Independent Technical Peer Review – Air Quality Impact Assessment

Mount Pleasant Optimisation Project

Project Number.: 0032

Date: 4 February 2022

Figure 1: On-site measurements of unsealed haul road silt content

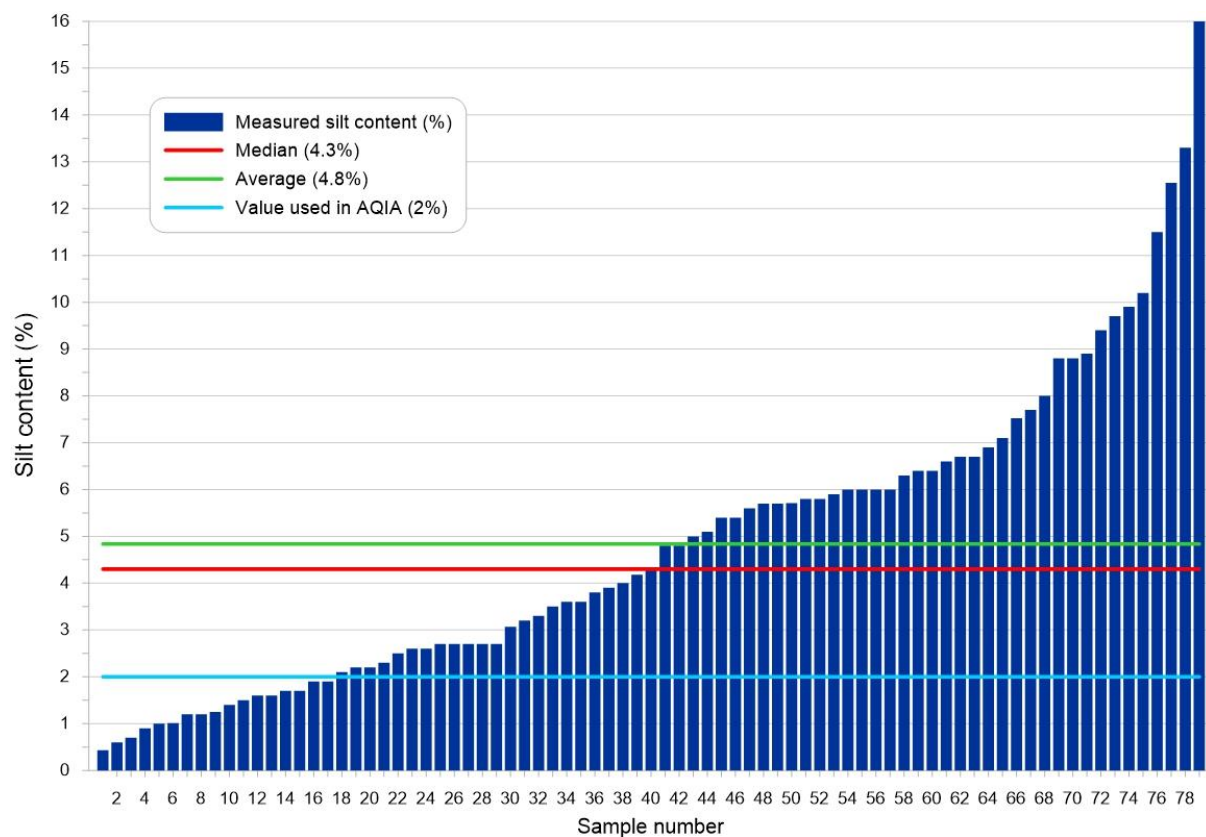
Figure 1 presents a summary of these measurements, as well as the additional seven values measured at Bengalla Mine and presented in Table 5 of the TAS response report (a total of 79 direct

measurements). The measurements are ranked from lowest to highest in Figure 1, which also notes the data average (4.8%) and the median (4.3%), as well as the 2% value used in the AQIA for comparison.

Clearly there is significant variability, but to propose that 2% is representative without demonstrating this through direct measurements is not supported.

Additional analysis by TAS (TAS, 2021) shows that an increase in silt content from 2% to 3% (still below the average and median) would result in more dust at the source (up to 11% increase in TSP). However, dispersion modelling has demonstrated that this increase does not necessarily translate into a significant increase in predicted concentrations at the nearest, previously unimpacted, receptors. The report also notes that the silt content would need to be of the order of 7-8% to result in an additional exceedance. While it may be unlikely that haul road silt contents are this high, Figure 1 shows this is not impossible as 20% of the measurements in the existing database are above 7%.

This issue can be **closed**. However, given the variability shown in values both between sites and within the same site, it is highly recommended that site specific silt contents be measured on a variety of haul roads to support the claim that this low value of 2% can be achieved. This was recommended in the original peer review (ERM, 2021) and again at the meeting on 29 November 2021. Our position has not changed.
